Request for Additional Information No. 371, Supplement 2

U. S. EPR Standard Design Certification

SRP Section: 03.07.01 - Seismic Design Parameters

Question 03.07.01-29:**Follow Up to RAI 215, Question 03.07.01-22:**

Figure 03.07.01-29-1: Comparison of Alpha-Beta / RG 1.61 Damping – HELB/Seismic

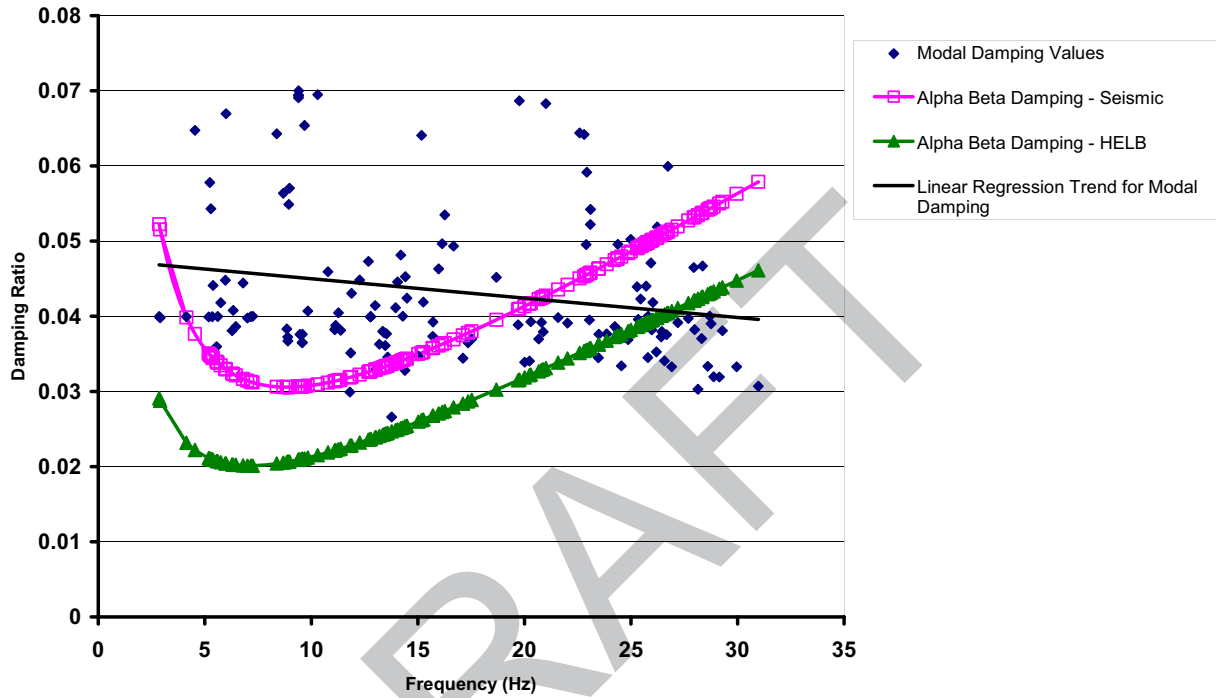
The applicant has provided a comparison between modal damping using RG 1.61 and Rayleigh damping using assumed values for alpha and beta. The alpha and beta values used to develop the Rayleigh damping curve in Figure 3.7.1-22-1 are 0.9 and 0.00045, respectively. According to Appendix 3C.4.2.1.1 of the U.S. EPR FSAR these values are not the values used for seismic analysis as was requested by staff but are the values used for the RCS four-loop high energy line break analysis. In Appendix 3C.4.2.2 a different set of values of alpha and beta are given for the RCS seismic analysis. These values are 1.7 for alpha and .00055 for beta. As such there is inconsistency between the applicant's response to RAI 03.07.01-22 and the FSAR Appendix 3C.4.2.1.1. Use of higher values of alpha and beta can result in damping values that may not be conservative.

1. The applicant is requested to explain why two different sets of alpha and beta values were used and provide justification for the use of the higher damping values in the RCS seismic analysis and include this information in Appendix 3C of the FSAR.
2. Appendix 3C.4.2.2.1 states that a cutoff frequency of 35 cycles was used in the linear modal analysis. Now that Bell Bend response spectra curves will be included in the certified design and as these curves contain significant responses above 35 cps, the applicant is requested to provide a basis for using a cutoff frequency of 35 cps in the RCS seismic analysis. Please include the technical basis for your response and update the FSAR accordingly.

1. As stated in Appendix 3C.4.2.1.1 of the U.S. EPR FSAR Tier 2, the high energy line break structural analysis of the U.S. EPR reactor coolant system (RCS) used values of 0.9 and 0.00045 for alpha and beta, respectively. These values provide conservatively low damping as compared to the modal damping values calculated using RG 1.61 guidance. Due to severity of seismic ground accelerations, a set of greater, yet still conservative, alpha and beta damping values was used to reduce RCS seismic analysis conservatism. U.S. EPR FSAR Tier 2, Appendix 3C.4.2.2.1 states that the alpha and beta values used in U.S. EPR RCS seismic structural analysis were 1.7 and 0.00055, respectively.

Figure 03.07.01-29-1 graphically compares results of alpha-beta damping values used for high energy line break and seismic analysis with results produced using RG 1.61 damping guidance.

The linear regression trend in Figure 03.07.01-29-1 represents a curve fit for the applied modal damping values. This figure shows that the seismic alpha-beta damping curve falls below the curve fit up to a frequency of 20 Hz. More than 98 percent of the lateral effective mass of the RCS components is accounted for below a frequency of 20Hz. The alpha-beta curve for High Energy Line Break analysis intersects the linear regression curve fit at about 28 Hz indicating that 99.5 percent of the RCS effective mass in all directions is damped below the modal damping allowed by RG 1.61.

Alpha-beta values used in the seismic analysis, as well as those used in the high energy line break analysis, are conservative.
